PLANNING COMMISSION AGENDA

Title: PUBLIC HEARING - PLANNED DEVELOPMENT OVERLAY (A-L/PD), WITH CONCEPTUAL SUBDIVISION PLAN ACCEPTANCE - FOR A MASTER PLANNED SINGLE FAMILY LOT SUBDIVISION - APPROXIMATELY 350 EAST ROLLING HILLS DR, LEONG -APPLICANT - **LEGISLATIVE DECISION**

STAFF REPORT AGENDA: ITEM 1

**CONCEPT PLAN FOR
JENSEN SUBDIVISION**
1975 ROLLING HILLS DRIVE
LOCATED AT THE SE 1/4 OF SECTION 31 T3N, R1E, SLB&M
CENTERVILLE CITY, DAVIS COUNTY, UTAH

C400
 SITE GRADING

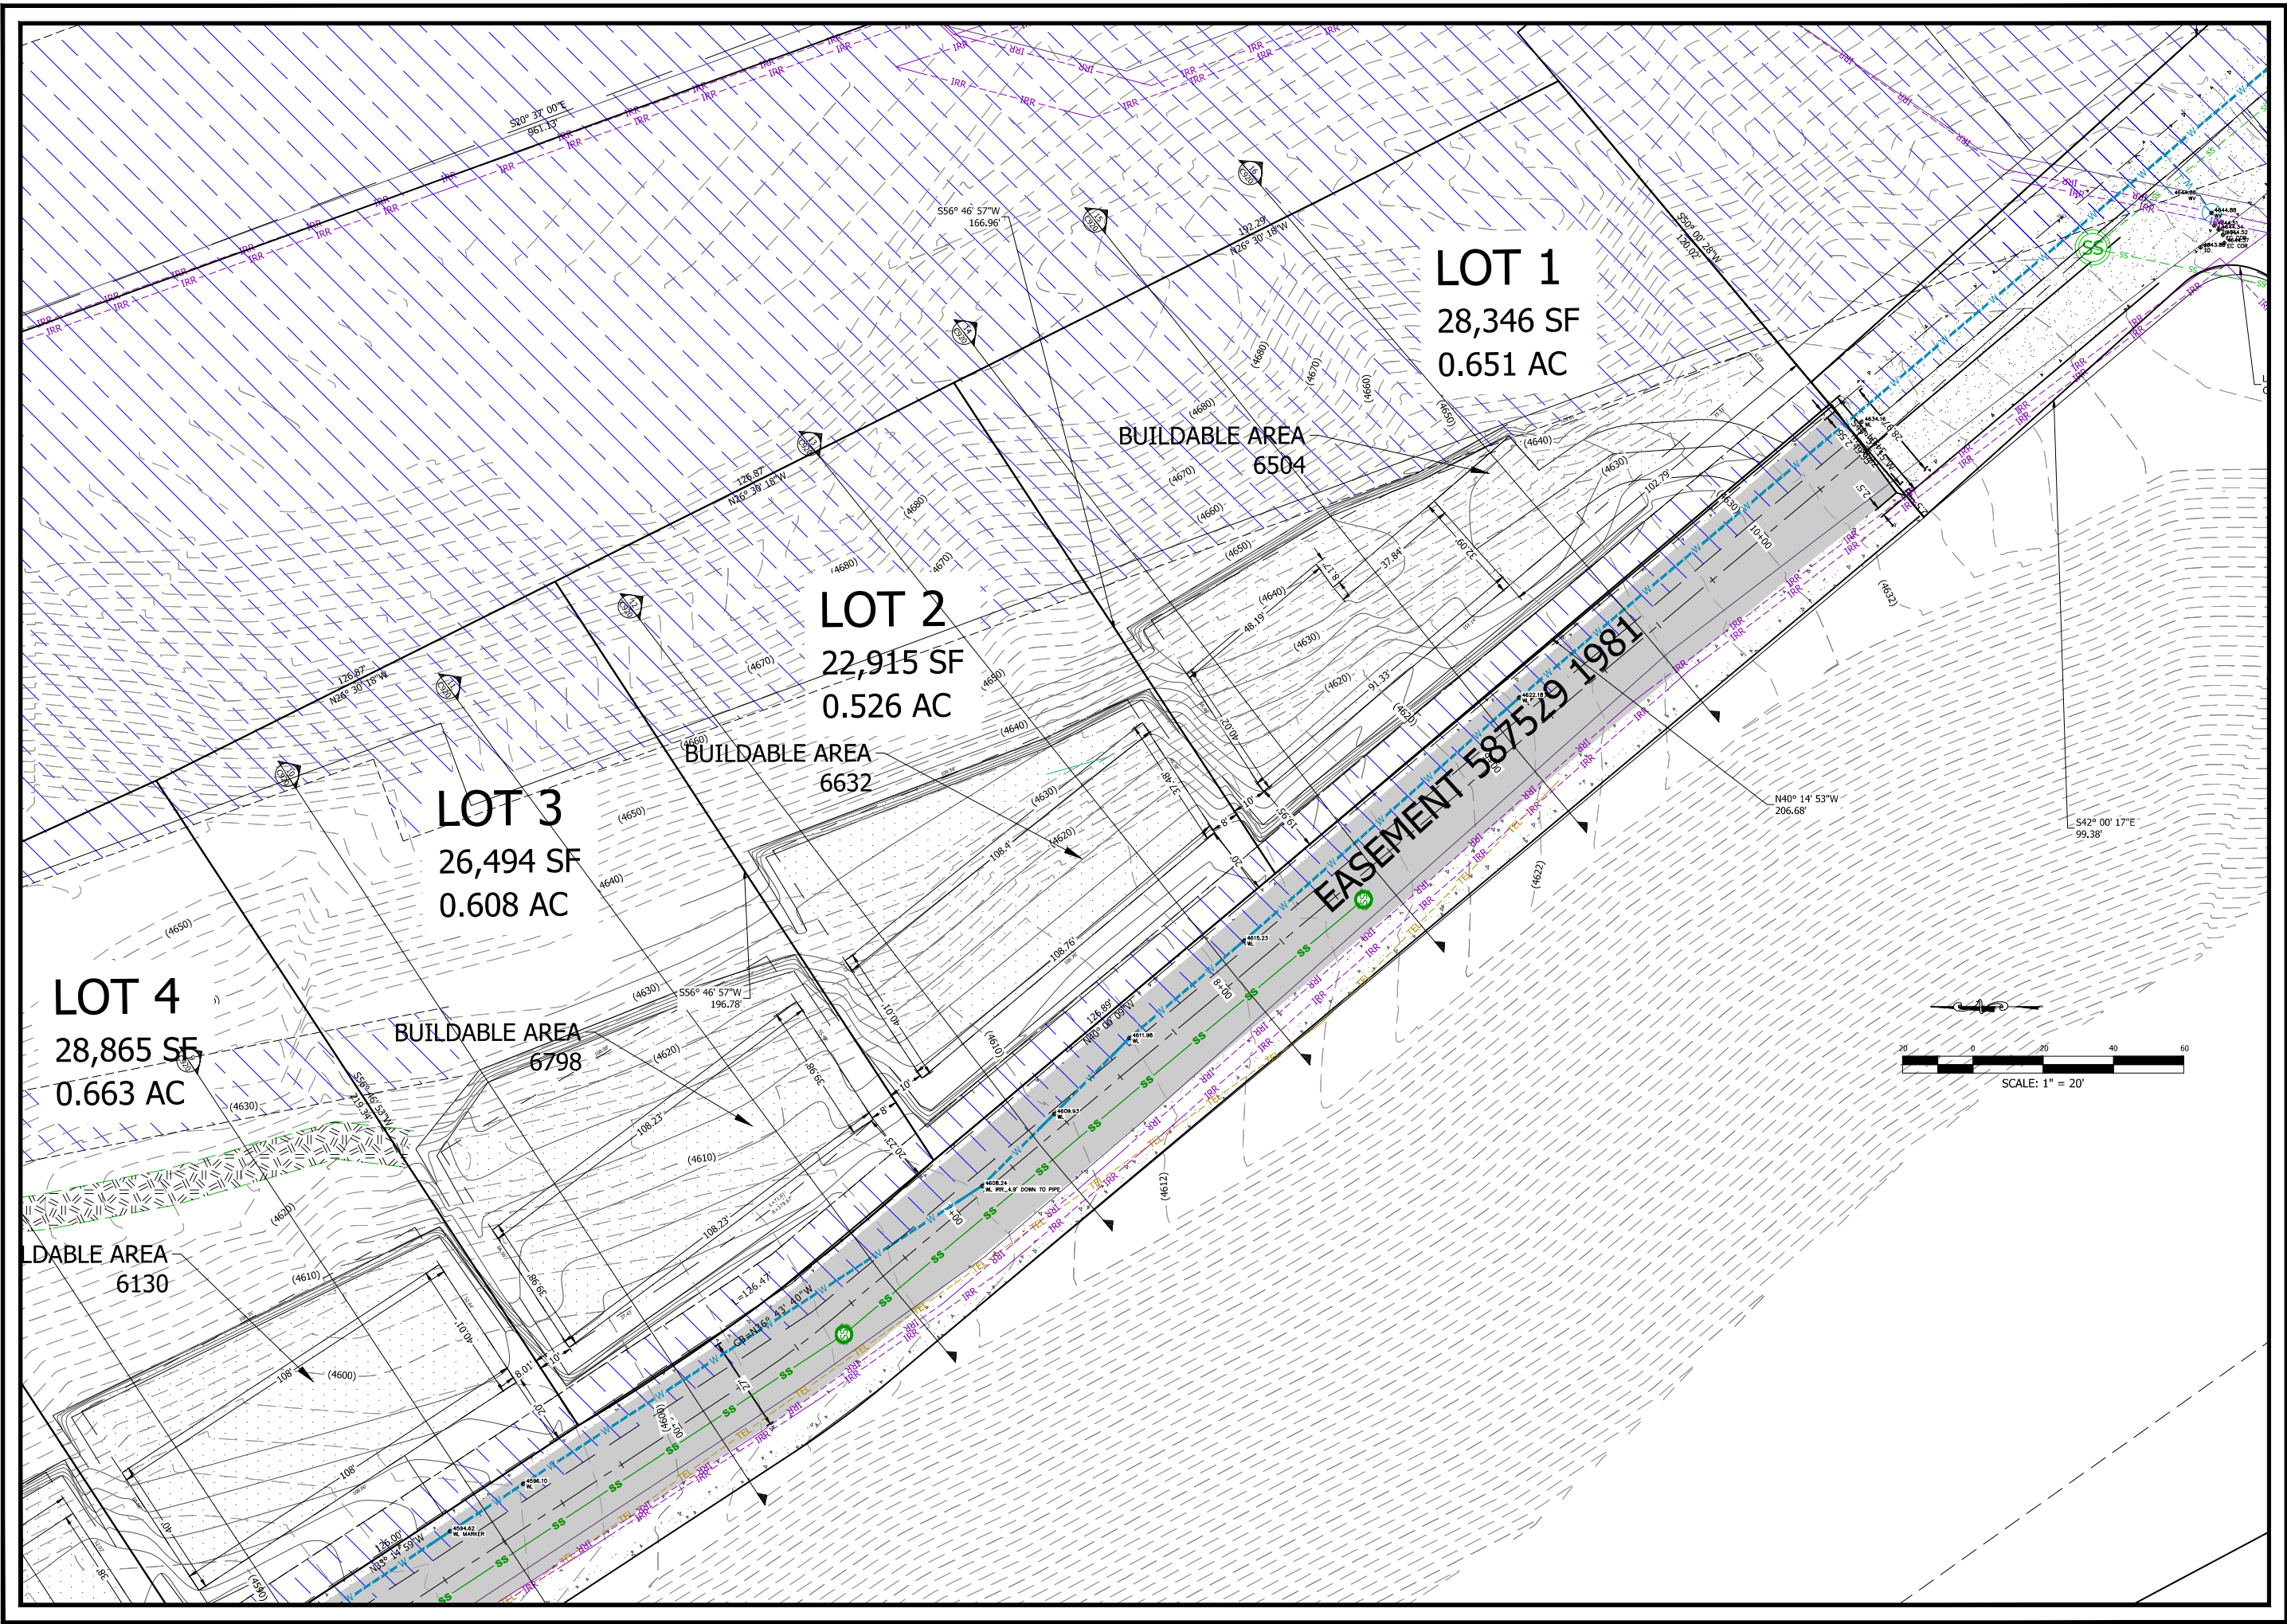
- ❖ CZC 12.42.040 - A Slope Analysis needs to be provided, as defined in the Hillside Ordinance.
- ❖ CZC 12.42.050 - The submittal needs to further address the cut and fill slope protection measures. Provided an overall revegetation strategy, which should be deemed acceptable/compliant by the City Engineer.

- d) *Address the slope area on the west side (i.e., downhill side of roadway), which needs to provide erosion protection measures to ensure that the dedicated roadway is not compromised with the future development of homes, causing the roadway to collapse.*

- e) *The submittal needs to further address the cut and fill slope protection measures to reduce or minimize such use and provide an overall revegetation strategy for the entire development.*
